Environmental Review Document – Response to Submissions

Perdaman Urea Project

Assessment No. 2184 (WA), 2018/8383 (Commonwealth)

Date: 16 April 2021

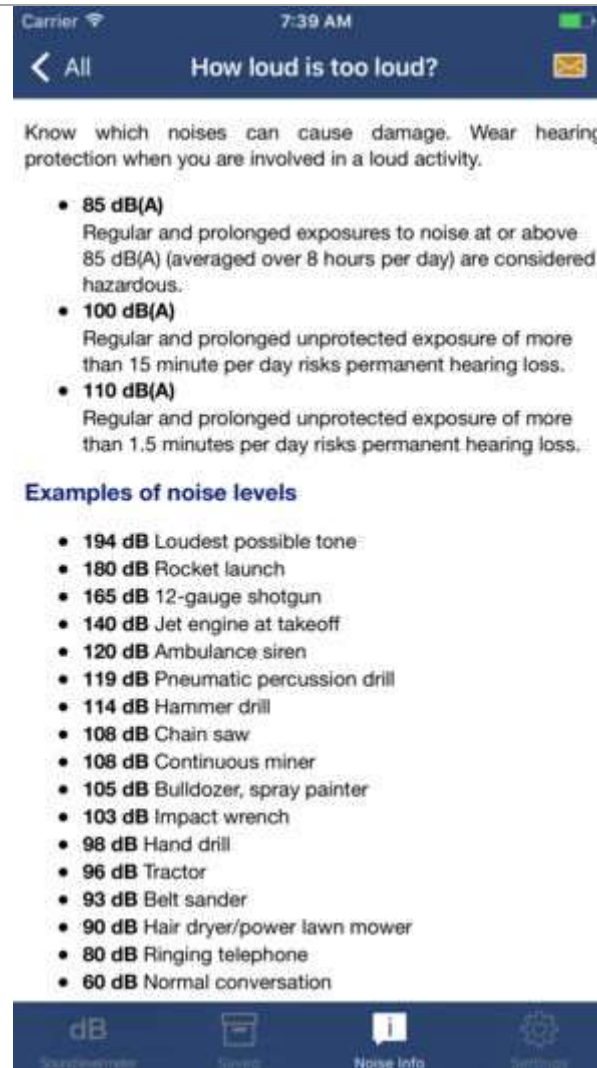
Specific Issue raise by MAC directly with EPA - the need for information on predicted noise levels at the Yatha and Fish Thalu sites within Site F (The EPA Services Directorate suggests that you should also include the National Heritage Listed (NHL) area within Site F);

The assigned noise level can be derived from the assessment report in ERD Appendix F. From Table 2-2 of that report, the assigned noise levels applicable at either Yatha or the National Heritage Listed Area sites within Site F would be 60 dB LA10, on the basis that these may be considered 'noise sensitive premises' but without a building associated with a sensitive use. Empirically, a noise level of 60 dB can be equated to a normal conversation. See below.

By way of further comparison, Figure 4-1 from the ERD report shows LA10 contours over the area in question also – see below.

(Researchgate: Urea Finishing Process: Prilling Versus Granulation, June 2014)

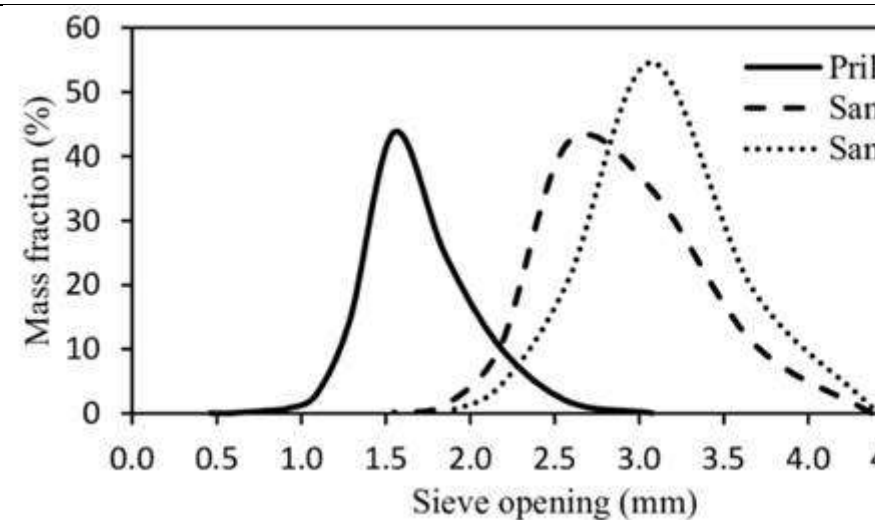
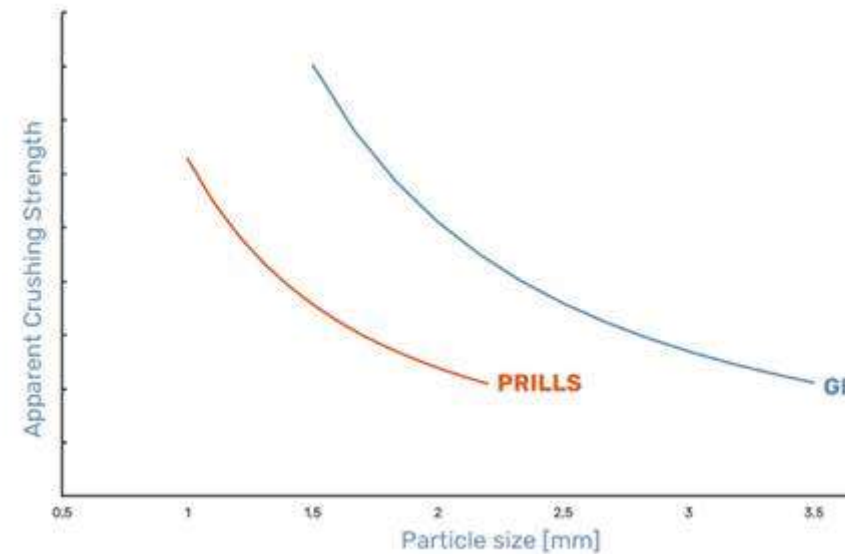
5) Part V of the EP Act through a licence can regulate both point source and fugitive air emissions from the Prescribed Premises aspect of the Urea Plant. It cannot regulate air emissions generated from infrastructure and operations occurring outside of the Prescribed Premises boundary, which may include ship loading infrastructure and conveyors. NOTE: Due to the nature of the product to be shipped, it is uncertain at this stage if ship loading infrastructure and conveyors would be regulated under Part V of the EP Act.	<p>The Proponent understands that ship loading may be a prescribed activity. While all conveyors are enclosed to the ship loader, it is unclear whether the final design will trigger Cat 58 or Cat 86 as loading of bulk material to a vessel of more than 100 tpd.</p> <p>Conveyor and Port storage will probably not be prescribed activities pursuant to Schedule 1 of the EP Regs, as the conveyor is fully enclosed the Proponent considers operational environmental impacts for conveyor will be low</p> <p>The potential 'dust' issue:</p> <p>Urea granules are engineered hard and tough to resist breakage and sized (in the granulation plant) to eliminate fines in the product (dust). There is thus only 1 collected dust point emission in the urea chain.</p> <p>1. Why granules are better than prills.</p> <p>The particle size distribution of granules avoids small particles such as with prills.</p>

Prills show a smaller average particle size distribution, but specifically a lot wider. Granules are shown with Sample 1 and Sample 2 on the figure.

The Sample 2 is representative of modern granulation -a tight (>92%) distribution around 3.0mm (this average diameter can be adjusted if desired, with screen selection). Australian farmers demand a high particle size precision, as most of their crop application is mechanised. There are essentially no particles <1.5mm. Further granulation adds a small amount of UF85 as 'glue' which strengthens the crushing strength of the urea granules; reducing potential for damage during handling.
